s72 Amendment and Secondary Consent Planning Assessment - Officer Report

PA2101392-4 141-169 Burwood Hwy, Burwood

Section 72 Amendment Planning Assessment - Officer Report
Development Assessment

Figure 3: Proposed amended site plan for endorsement aligning within WH/2025/253 endorsed plans

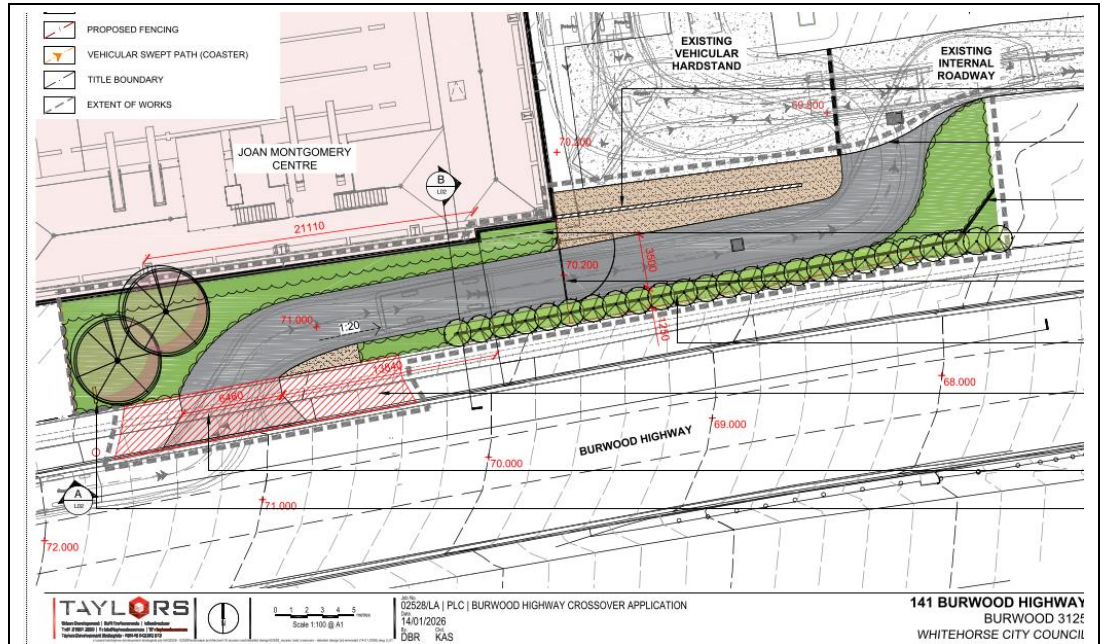
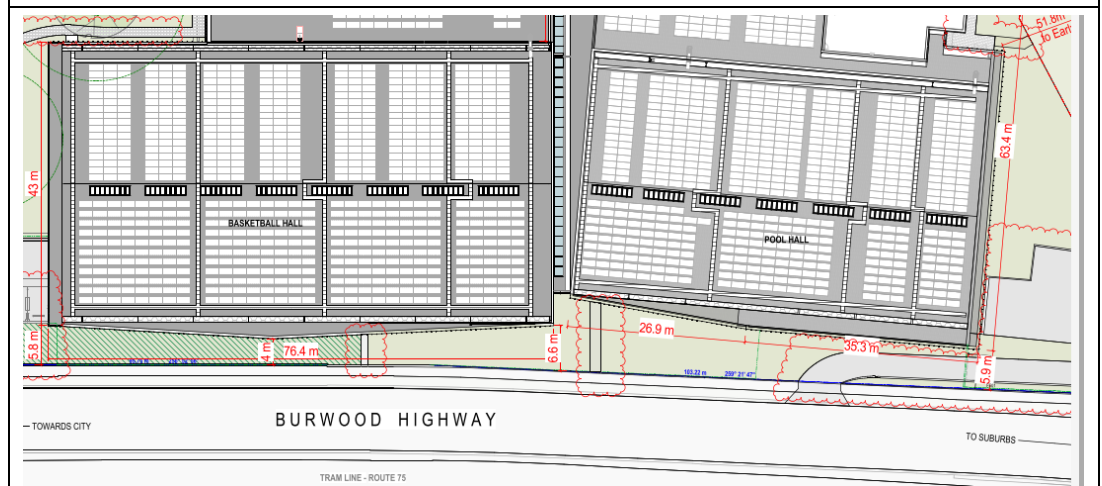
Change / Comment	
Proposed Change	<p>Inclusion of crossover details approved under council issued permit WH/2025/253 (issued 8 January 2026)</p> <p>An additional vehicle crossover to Burwood Highway is proposed to the south-east of the JMC which is to provide entrance access only and seeks to assist in alleviating the existing queuing issue on Elgar Road during PM pick-up periods.</p>

This addition is noted to require primary consent pursuant to clause 52.29 (land adjacent to the principal road network), however has been approved by council separate to the subject permit under council issued permit WH/2025/253). It is noted that as part of such assessment Head Transport for Vicotria was a determining authority and consented such approval.

The proposed amended site plan seeks to include the information of this crossover approved under the council issued permit for clarity and consistency between permits and respective endorsed plan sets.

The proposed change to site plan includes details of the as-built crossover of which has been approved by the council. The change is considered to be acceptable given planning permit permission

has been granted external from the subject permit, and this update merely seeks to depict current site conditions.

Figure 4: Currently endorsed (left) vs proposed (right) JMC carpark

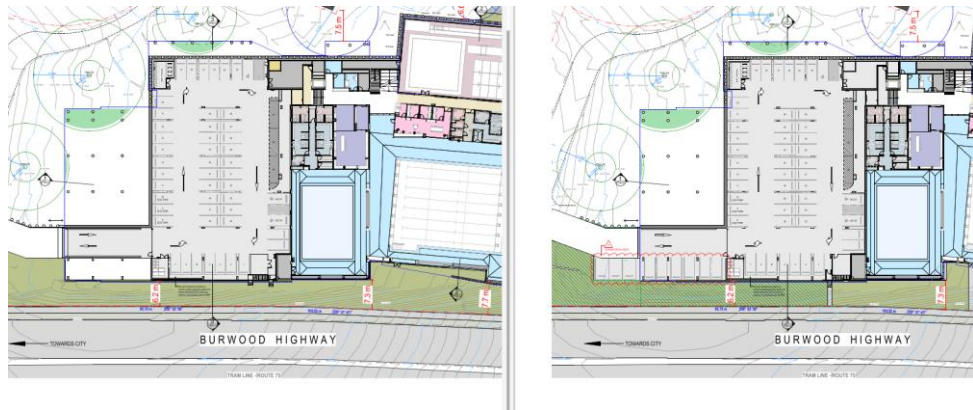
Changes to the JMC carparking area are as follows:

- Minor internal redesign within the JMC car park where the newly proposed pedestrian path joins to the JMC.
- Inclusion of an additional 3 car parking spaces to the south-west corner of the JMC. Externally, an additional four (4) car parking spaces are proposed, while internal to the driveway entrance to the JMC car park, an additional six (6) car parking spaces have also been delivered.
- Minor changes to the carpark accessway ramp steepness grade from 1:12 to 1:26

The proposed changes to include additional on site carparking still maintains compliance with the onsite carparking requirements of clause 52.06 and furthermore results in an appropriate response to the design standards of clause 52.06-9 on the basis of the following:

- It is noted that the previously noted 1:12 grade of the 'ramp' has now been updated to reflect the as-built arrangement. During construction, this internal road was instead built to 1:26 and 1:37. 1:26 (3.85%) and 1:37 (2.70%) are less than the maximum 5% grade per AS2890.1, and on this basis is considered to be acceptable.
- The balance of clause 52.06-9 design standards are not impacted by the changes.

These changes are considered acceptable.
